# Access Compliance Report

### (Curb Ramps)

Intersection ID: 4883	Main Street: HEDGECREST_PL	Cross Street: MARIONWOOD_DR	Location:	S
ADA ID: 9D39BC9D9096	Ramp Type: Perp	Initial Pass/Fail: Fail	Overall Compliance: No	Severity Score: 37.5

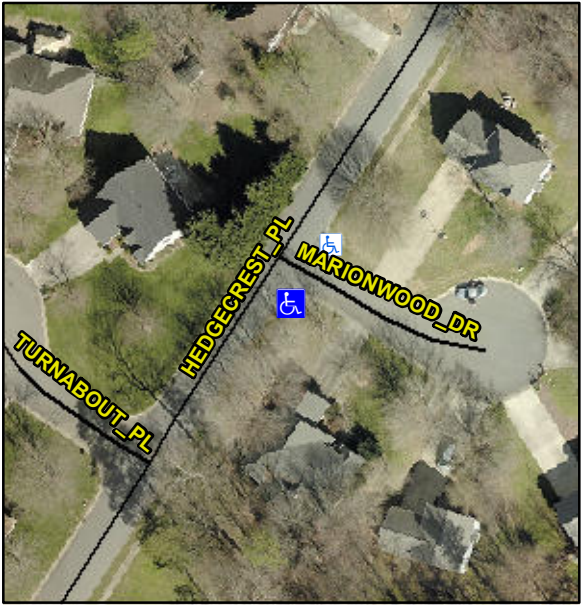
Codes/Mitigation Info/Possible Solution		Field Measurements/Component Compliance					
	Possible Solutions:	<b>Remove &amp; Replace Entire Ramp.</b>					
	Surveyor Notes:	N/A					
	PROW/ADA:	Not Found, R304.2.2, R304.5.3					
	Street 1 Name	MARIONWOOD DR					
	Stop Condition-Street 2	StopSign					
	Street 2 Name	N/A					
	Stop Condition-Street 1	N/A					
	Total Cost:	\$ 1850.00					
		Compliance	Description	Data	Compliance	Description	Data
		N/A	Ramp Length (in)	48.0	No	Ramp Slope (%)	8.6
		Yes	Ramp Width (in)	48.0	No	Ramp XSlope (%)	7.8
		N/A	Flare Type LT	N/A	N/A	Flare Type RT	N/A
		N/A	Flare Slope LT (%)	N/A	N/A	Flare Slope RT (%)	N/A
		N/A	Flare Traversable LT?	N/A	N/A	Flare Traversable RT?	N/A
		N/A	Landing Length (in)	N/A	N/A	DWS Provided?	N/A
		N/A	Landing Width (in)	N/A	N/A	DWS Contrast?	N/A
		N/A	Landing Slope (%)	N/A	N/A	DWS Length (in)	N/A
		N/A	Landing X Slope (%)	N/A	N/A	DWS Full Width?	N/A
		N/A	Landing Curb? (Y/N)	N/A	N/A	DWS Offset (in)	N/A
